ADDENDUM NO. 5

DATE: May 7, 2019
FROM: City of Grand Junction Purchasing Division
TO: All Offerors
RE: Raw Water Irrigation Supply and Waterline Replacement IFB-4611-19-DH

SHEET NO.
C2.12

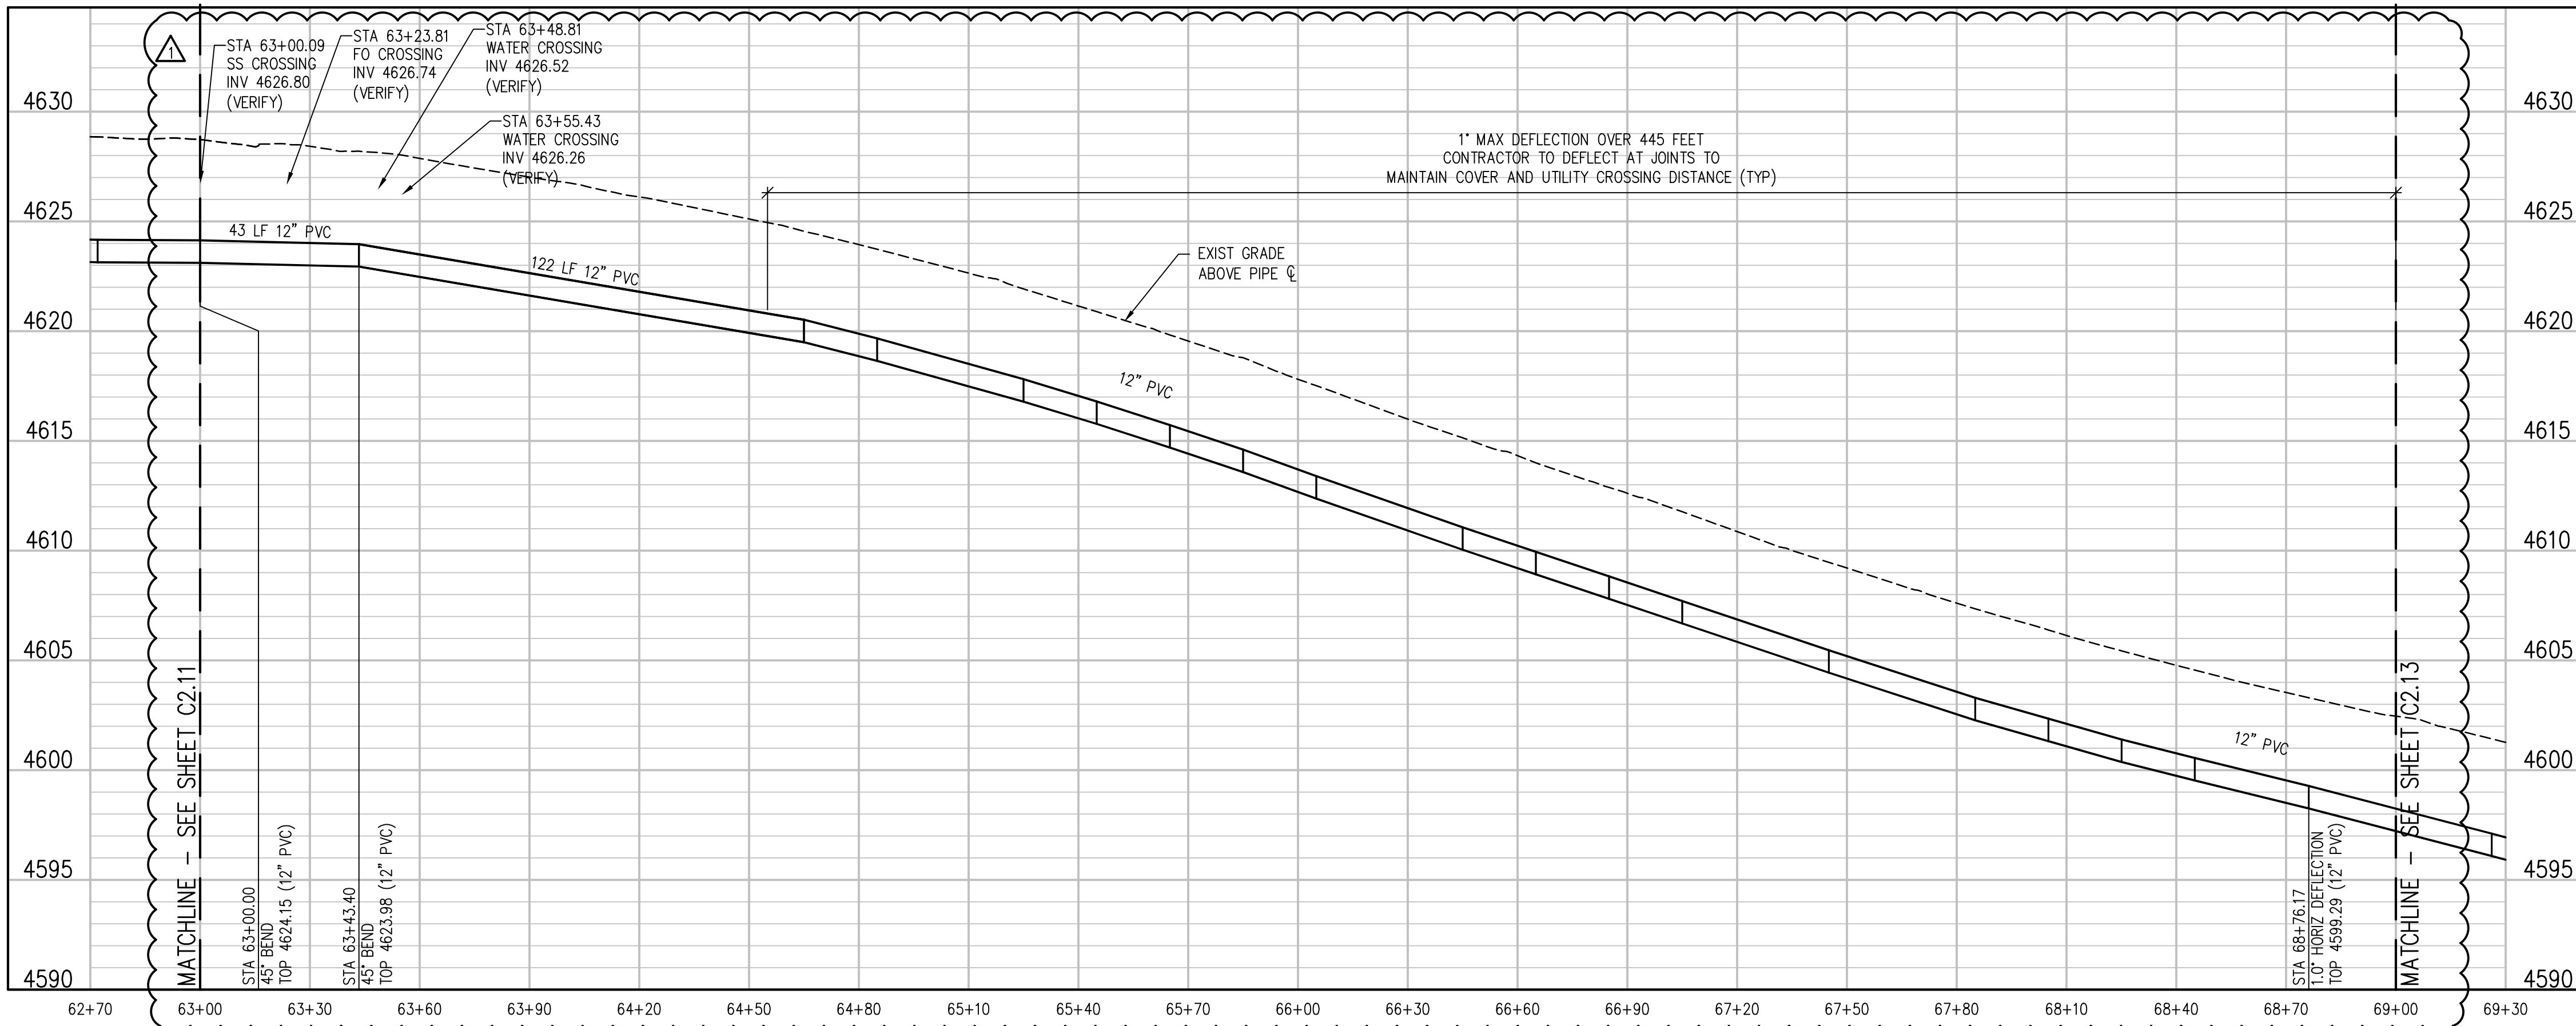
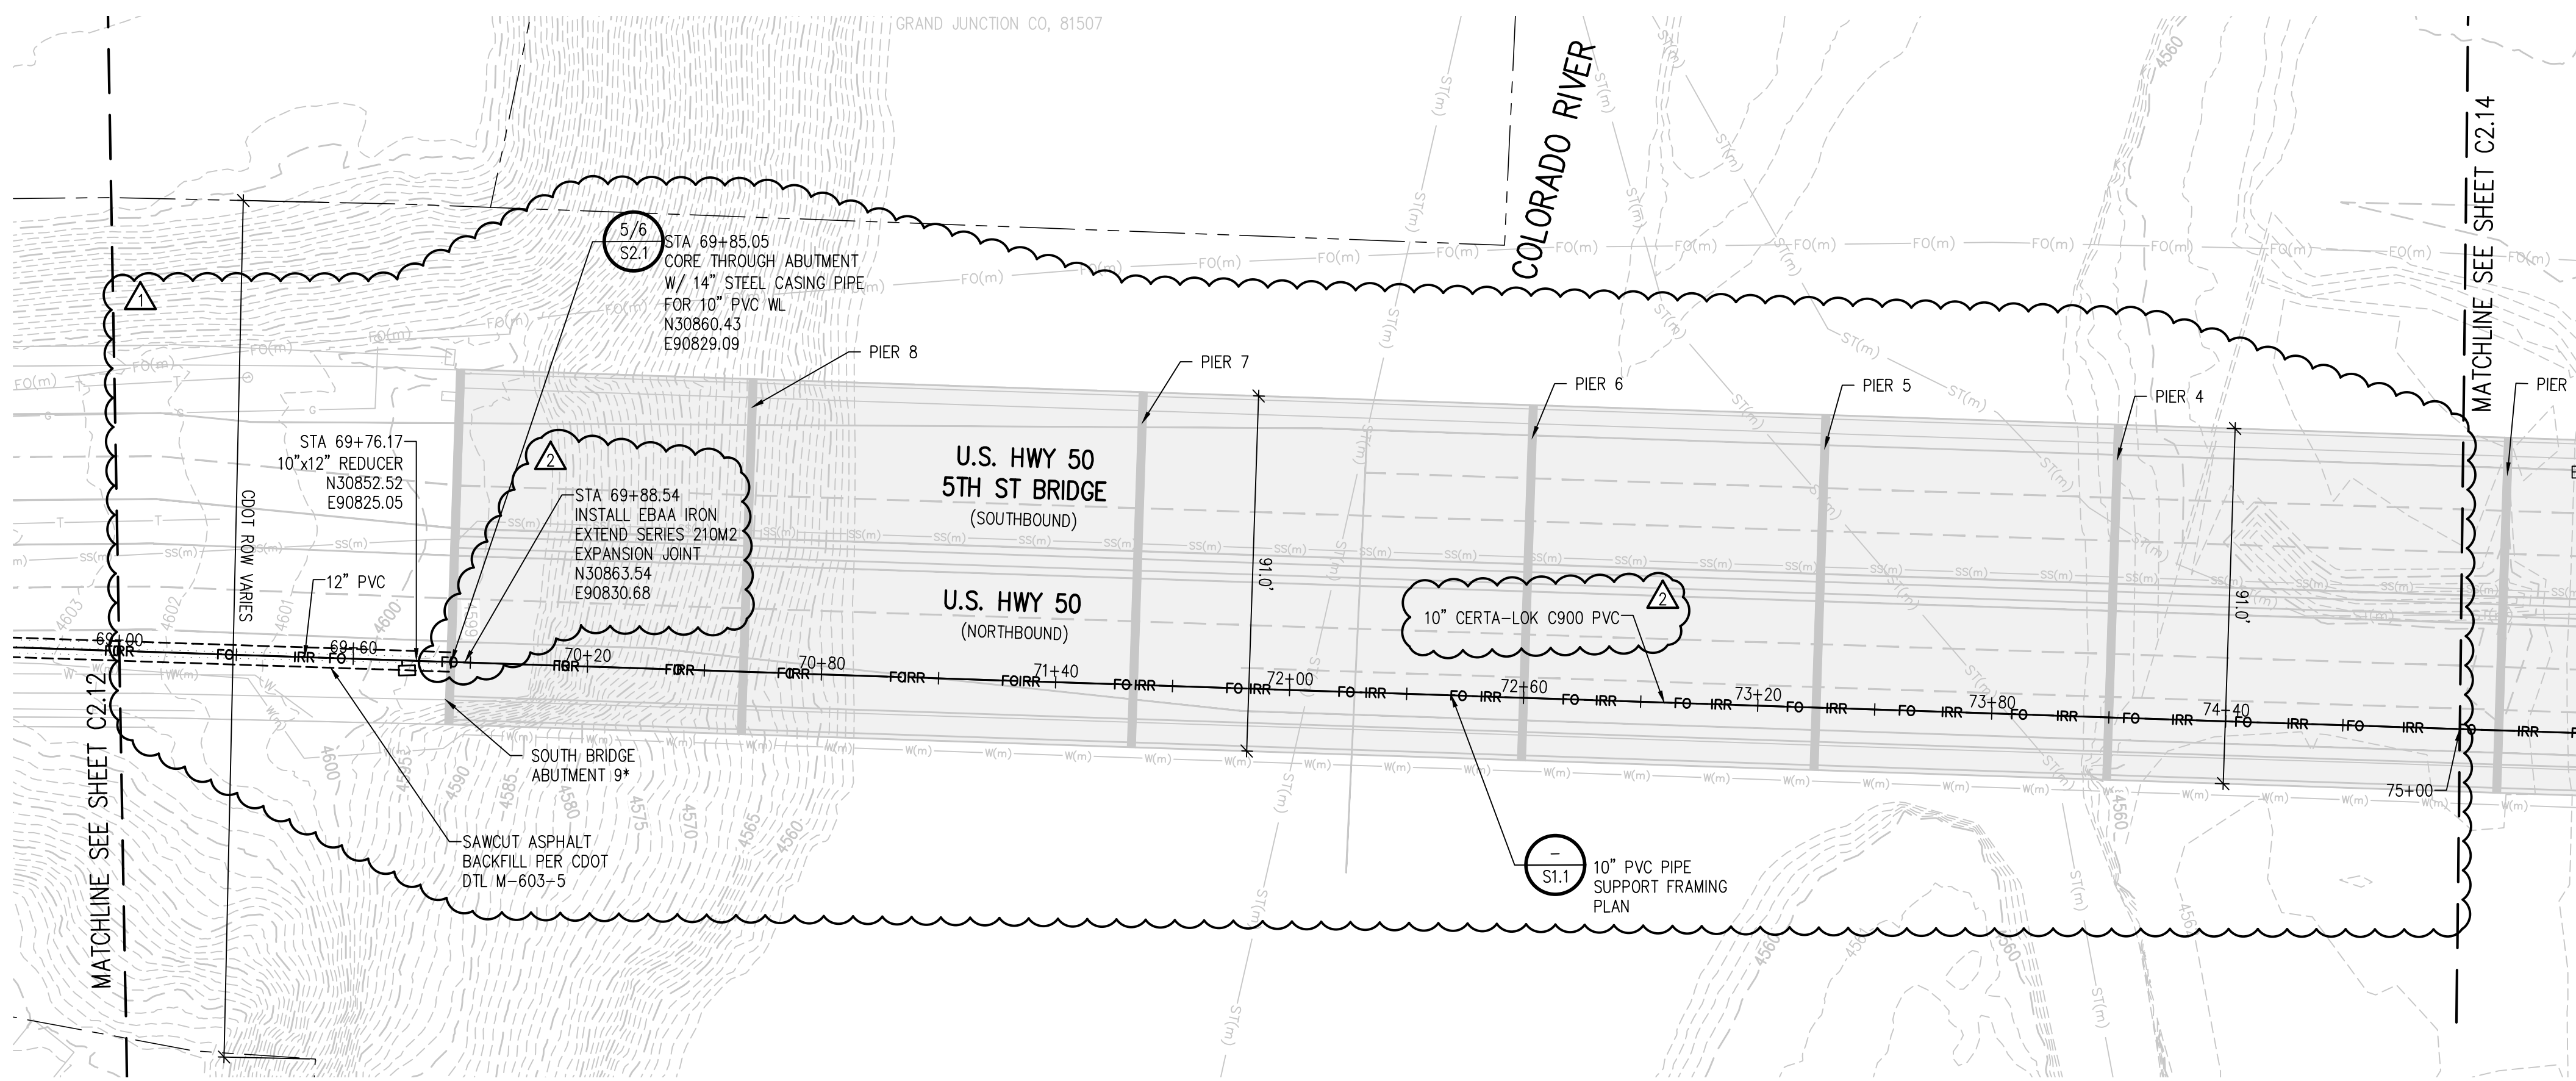
29. Q. Site investigation of the bridge crossing reveals that the pipe alignment as shown on the drawings will be in direct conflict with the 4" steel deck drains. Observation also shows that there is conflict with the mid-span girder diaphragms and the pier diaphragms. How will these conflicts be avoided? Will bends be allowed on the pipeline under the bridge in order to wave through for clearance?

31. Q. The plans indicate 10" PVC pipe without restraints or full casing to be installed under the bridge. We have never seen this done on past projects. Are there provisions for joint restraints on the PVC pipe? If casing is required, we need to know what size, type and thickness.

A. Revised alignment addresses this issue. Pipe was shifted to east side of bridge. Refer to Sheets C2.12-C2.14.

A. Pipe spanning under Hwy 50 bridge will be Certa-Lok C900 PVC with EBAA Iron Extend Series 210M2 Expansion Joints at both ends. Refer to Sheets C2.12-C2.14.

WALL PENETRATION WITH CORE HOLE DETAIL (2)
NTS

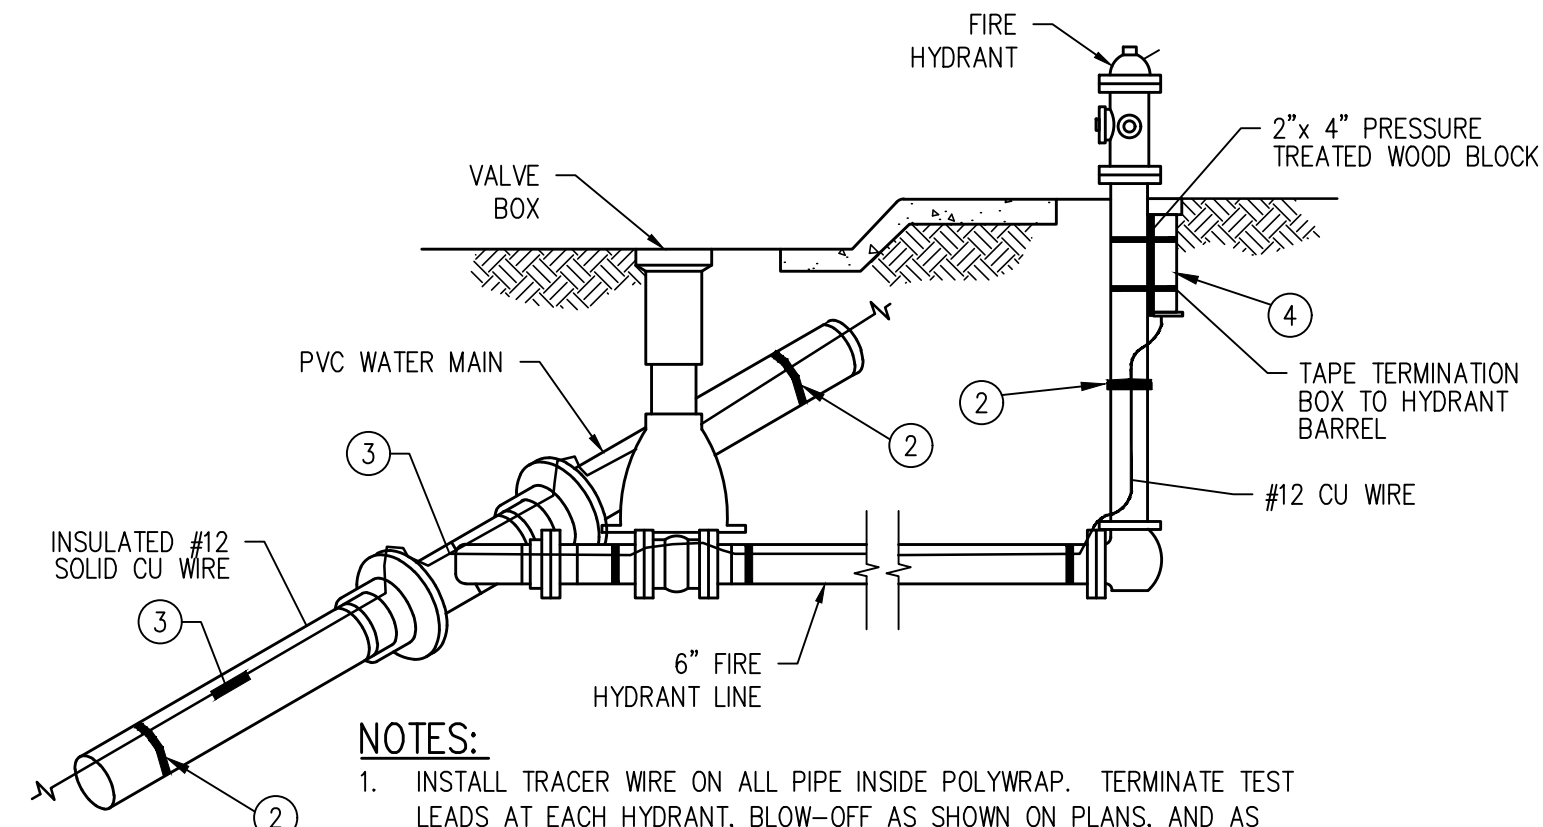
- a. A detail and spec are provided for spacers but no indication where required (detail note for waterline lowering shows casing but states if specified, no indication of requirement for project)
- b. Are casing spacers required on fusible pipe into existing RCP?
- c. Addenda 3 Q&A #10 unclear.
 - i. Is bridge pipe intended to be encased. Detail 6/S2.1 appears to show 10" PVC through casing/sleeve through abutment wall only, please clarify, additional detail on sheet S2.1 do not indicate steel casing
 - ii. If only abutment is encased/sleeved are link seal required on penetration per plan detail 2/C2.3, or where does this detail pertain to?

A. The 14" goes through the abutment wall only. Pipe spanning under Hwy 50 bridge will be Certa-Lok C900 PVC with EBAA Iron Extend Series 210M2 Expansion Joints at both ends. Refer to Sheets C2.12-C2.14. Link Seal is required, refer to Detail 2, Sheet 2.3.

5 DETAIL
 C4.0 3/4" = 1'-0"

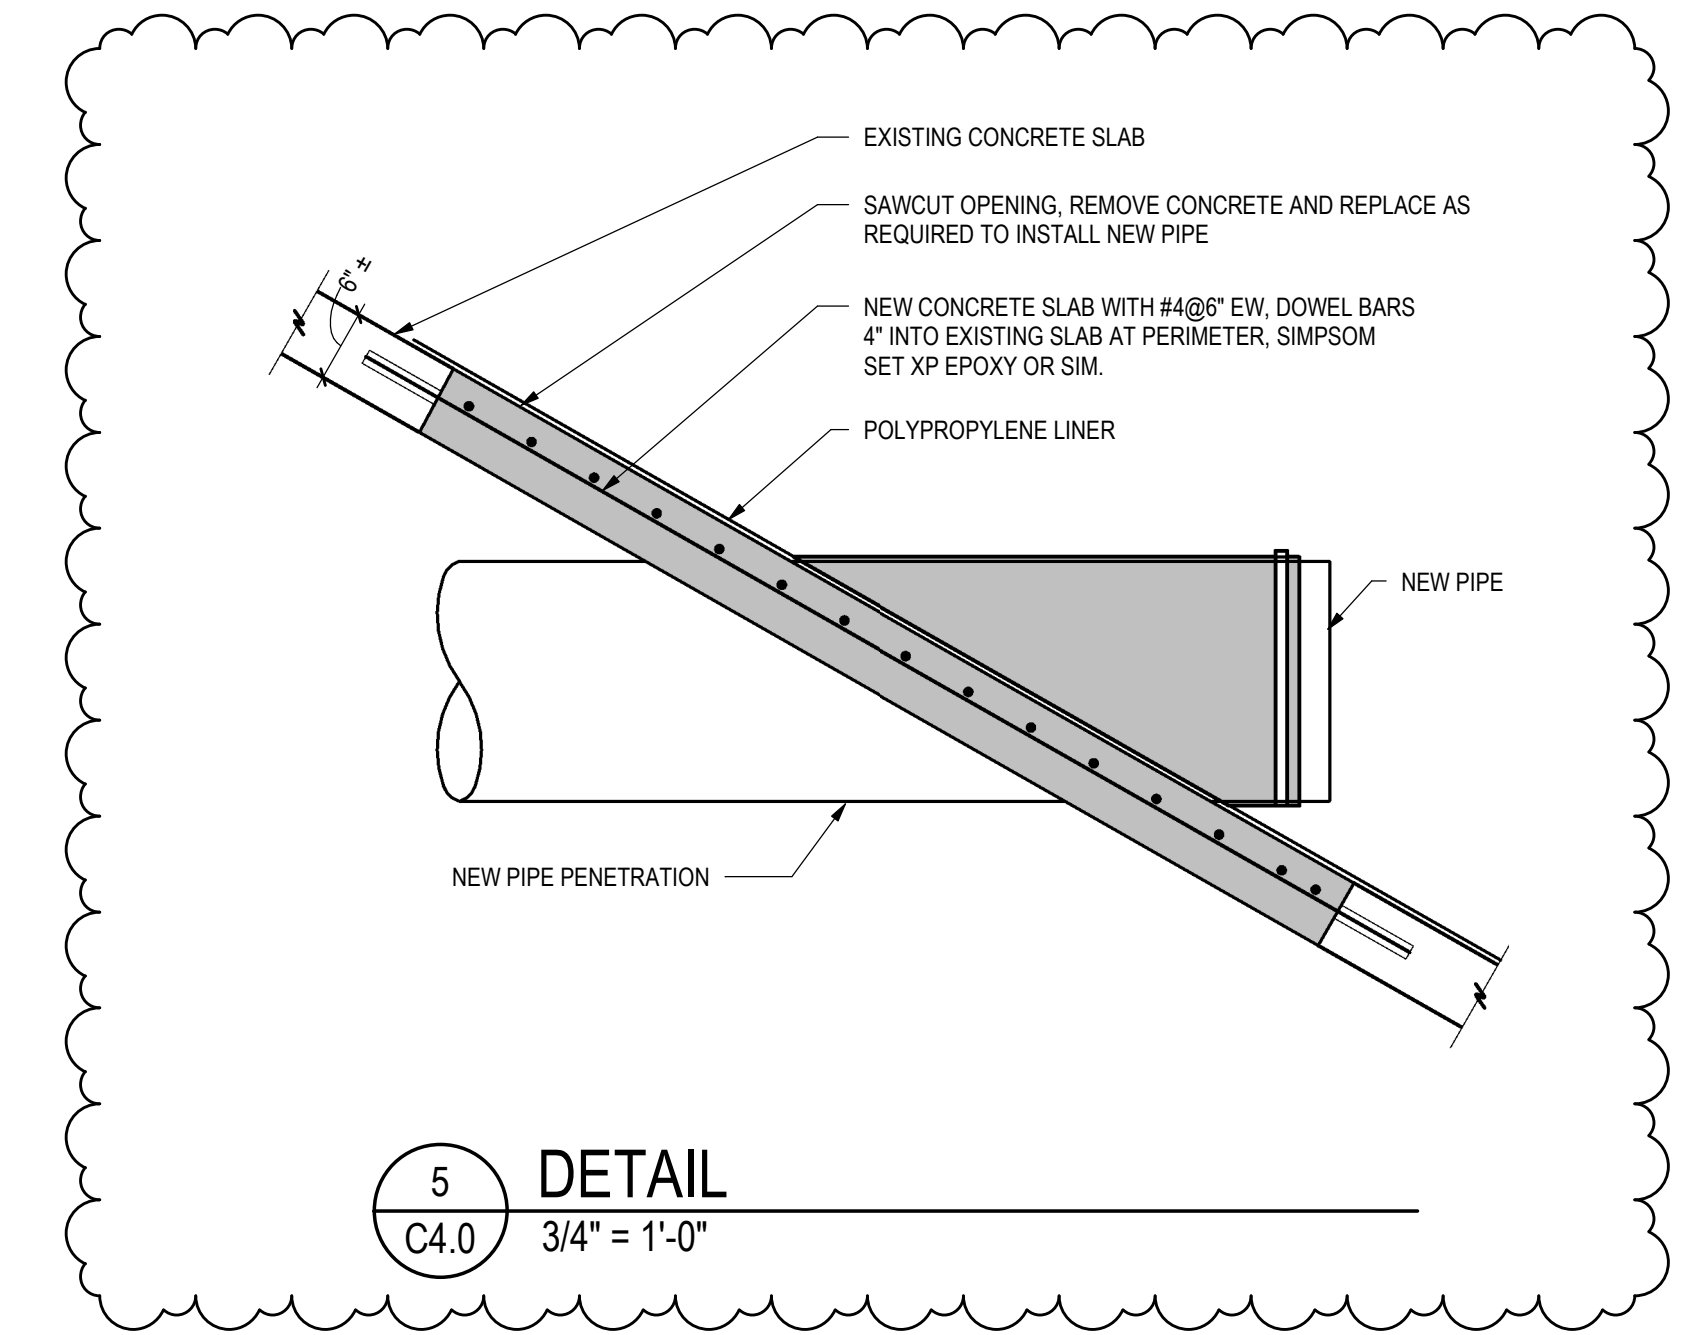
22. Q. Addendum 3, answer #17. Seems to be confusion on the question. Was not asking if the pipe needed to be installed prior to the HDPE liner, was asking how the pipe penetration into Reservoir #3 was to be made. Detail 2/C2.3 is for a vertical concrete wall penetration, not a sloped wall as Reservoir #3. Need detail on how this connection will be made.

23. Q. Addendum 3, questions 17 and 37, answer 37. Both questions address making the connection into Reservoir #3. Since the existing concrete liner is at a 1.75:1 backslope, either concrete panels need to be removed and replaced to facilitate installation of the new piping into the reservoir or a detailed drawing needs to be provided to show how this is to be constructed without excavation. It is not possible to excavate under the concrete and leaving it hanging in the air for pipe installation below. Please address this issue.

A. Refer to Detail 5, Sheet C4.0.

A. Refer to Detail 5, Sheet C4.0.
